**EPA's Proposed MACT Floor Standards for
Mercury Emissions from Coal-fired Utility Units:
A Statistical and Analytical Assessment**

A White Paper

**DEPARTMENT OF ENVIRONMENTAL PROTECTION
DIVISION OF SCIENCE, RESEARCH & TECHNOLOGY**

Figure 1. Resizing MACT; bituminous and subbituminous coal-fired utility units

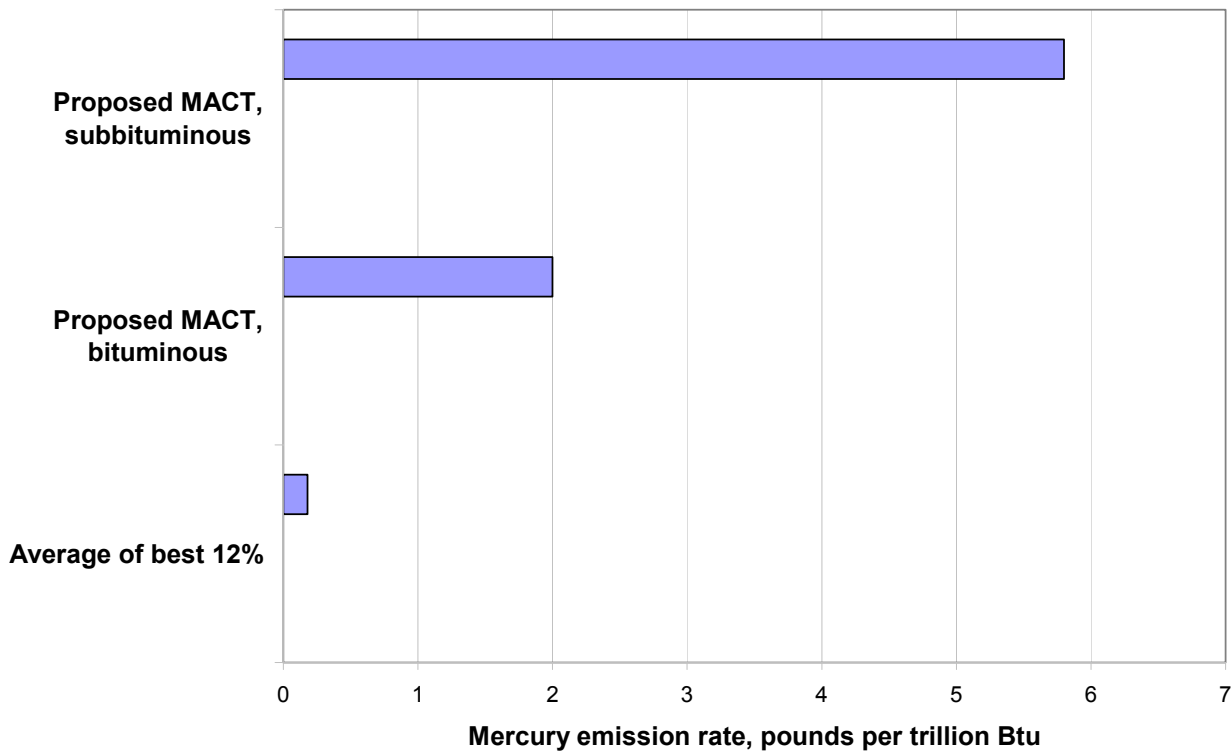
As a result, the proposed MACT standards would allow substantially greater emissions of mercury than what the best performing 12% are achieving today. EPA proposed a MACT standard more than 30 times greater than 0.18 lb/TBtu average emission rate that the best performing 12% achieved in practice: 5.8 lb/TBtu for units currently firing subbituminous coal, or for units that switch to subbituminous coal from bituminous coal. For units that continue to fire bituminous coal, EPA proposed a standard of 2.0 lb/TBtu, more than 11 times greater.

The following chart illustrates the difference between what the best performing 12% are achieving today and the standards that EPA proposed.

Figure 2. Portion of Hg inlet conc. that is particle-bound or oxidized vs. control efficiency all tests for all units

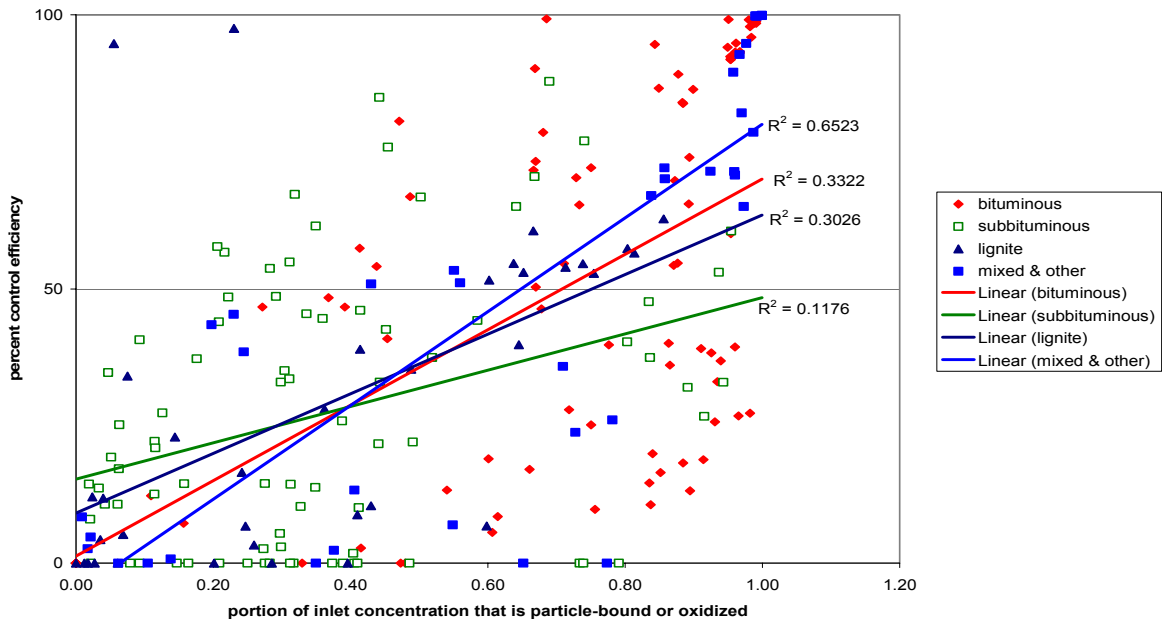
Analysis of ICR III⁷ data by the NJDEP suggests that a relationship between mercury control and the portion of inlet mercury that is either oxidized or particle-bound is plausible. See Figure 2. However, EPA offers no evidence and cites no sources to demonstrate a significant correlation between the chlorine:mercury ratio and the ability to control mercury emissions. As Figure 3 shows, there is no apparent correlation between the chlorine:mercury ratio of all coals and the portion of the inlet concentration that is oxidized.

Figure 4. Ratio of Cl to Hg vs. control efficiency

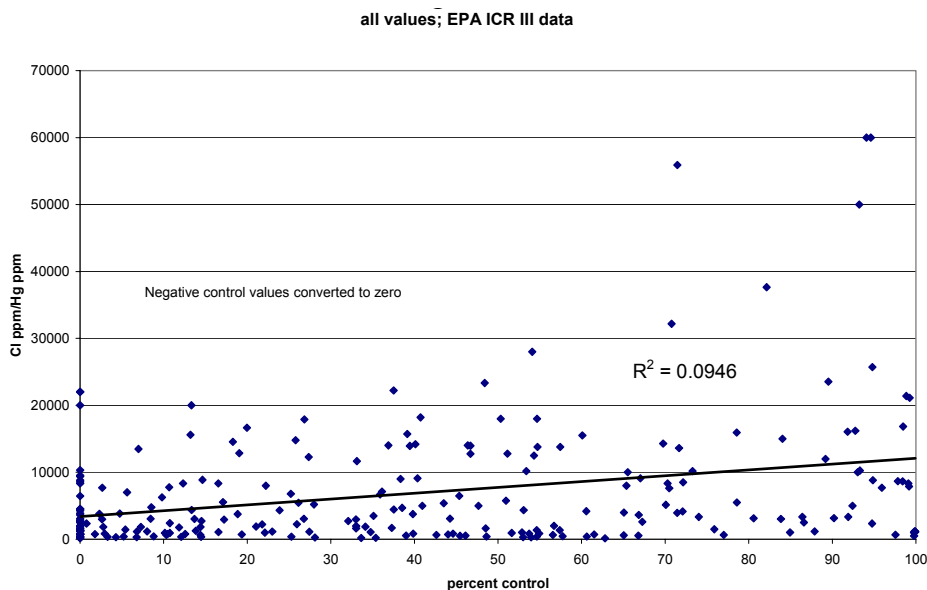
As Figure 4 shows, the highest chlorine:mercury ratios are associated with relatively good control. However, as is also clear from Figure 4, there are just as many, if not more, units with good control that are burning coals with low Cl/Hg ratios. Clearly other

factors are involved in the achievement of good control than coal's chlorine content. For these reasons, it is unlikely that there is anything more than a weak correlation between the chlorine/mercury ratio of the coal to the percent of mercury emissions controlled.

Figure 5. NJDEP Recreation of ENSR Plot of Fabric Filter/ Spray Dryer Absorber

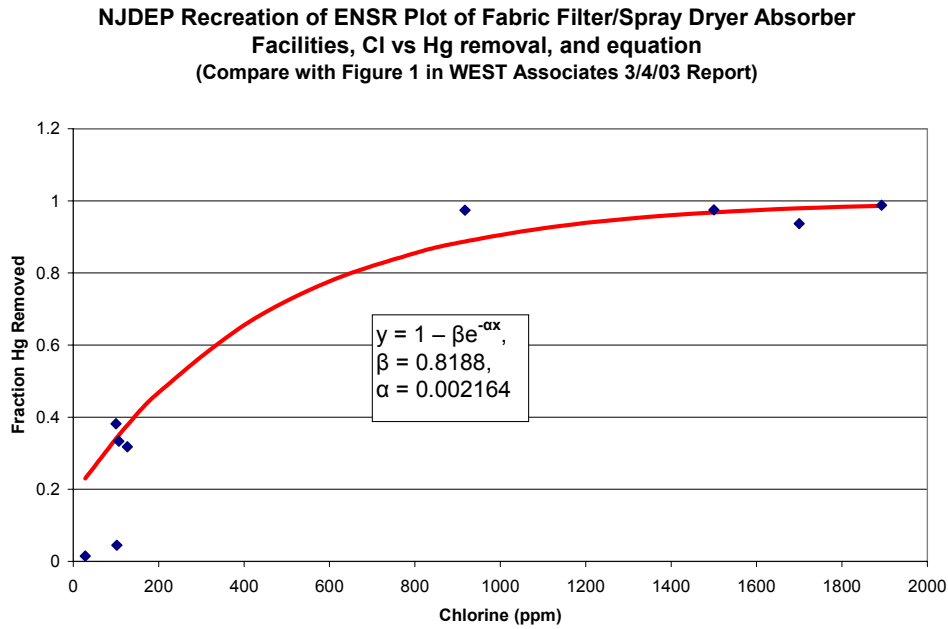
WEST claims that the best-fitting equation, $F_{\text{rem}} = 1 - 0.8188 * e^{(-0.002164 * Cl_{\text{ppm}})}$ is associated with an R^2 value of 0.935. The NJDEP used the data listed by WEST¹¹ to develop its own plot of the data, and concluded that WEST overstated the R^2 value and therefore also overstated its value in predicting mercury emissions. A recreation of the WEST analysis by the NJDEP (Figure 5) found that the R^2 value is only about 0.85, not 0.935 as claimed. Furthermore, although WEST claimed to use the data from 9 of the 10 units,¹² it appears that WEST actually plotted only 8 of the 10 units, further detracting from claims of predictive value with respect to mercury emissions.

Figure 6. NJDEP Version of Plot of Fabric Filer/Spray Dryer Absorber Facilities

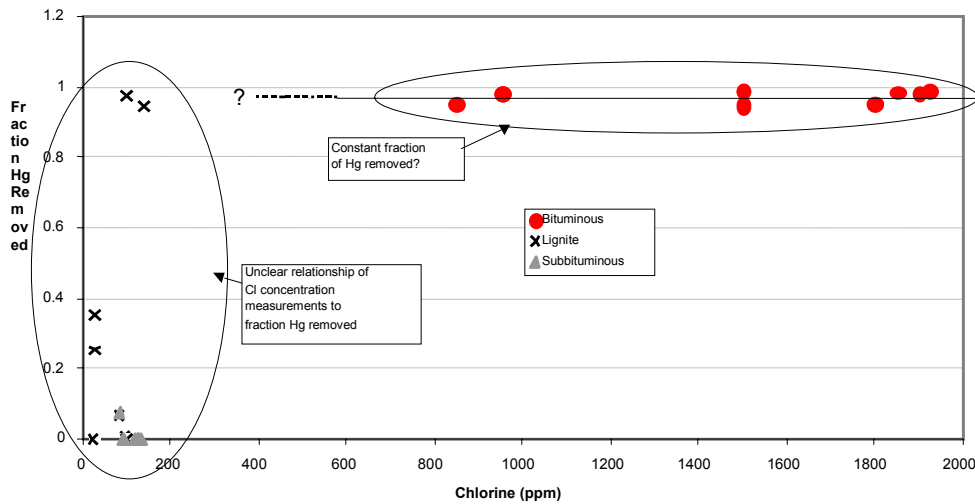
Closer analysis reveals the model fit is even poorer. See Figure 6. This figure shows all the data for the FF/SDA units instead of the averages of the three values for each unit as WEST did. The figure also separates the coals by rank instead of lumping them together as WEST did. Inspection of the figure suggests that there could be other models that might fit the data better than the equation form used. It could be that there are in fact two subgroups of units in this group, bituminous coal burners and those burning other ranks of coal. The best approach might be to fit a separate equation to each group. One such equation, for bituminous burners, might be virtually a horizontal straight line, with control efficiency above 90% regardless of chlorine concentration.

Particularly problematic is the fact that, as shown in Figure 6, the range of values corresponding to the fraction of mercury removed for coals with chlorine concentrations between approximately 150 ppm and 850 ppm is totally undefined by the data. Nevertheless, the equation used by EPA, corresponding to the values depicted in Figure 5, was used to predict mercury emissions from some units burning coal with chlorine content corresponding to these undefined values.
